**Amendments to the Drawings:**

The attached replacement sheet of drawings include changes to Fig. 4. The sheet replaces the original sheet 3/4.

ANNOTATED SHEET SHOWING CHANGES

10007153  
3/4

FIG. 4

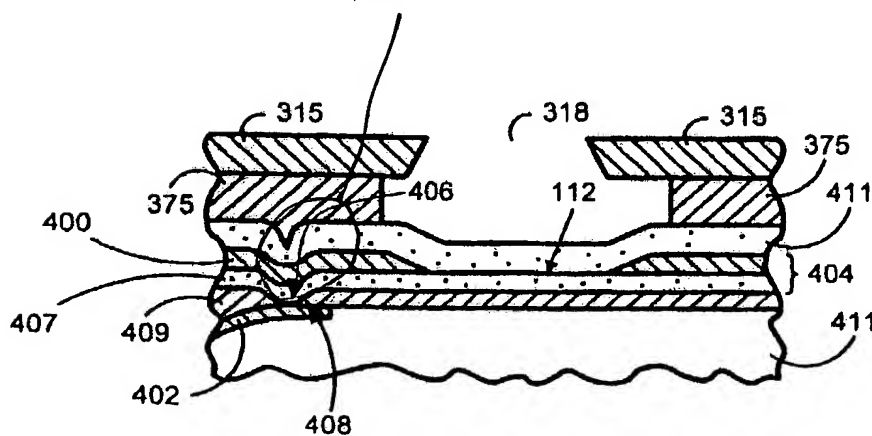
In FIG. 4, the lead line from reference number 406 is changed to more closely point to the via 406.

*Arrow for ref. no. 406 lead line extended.*
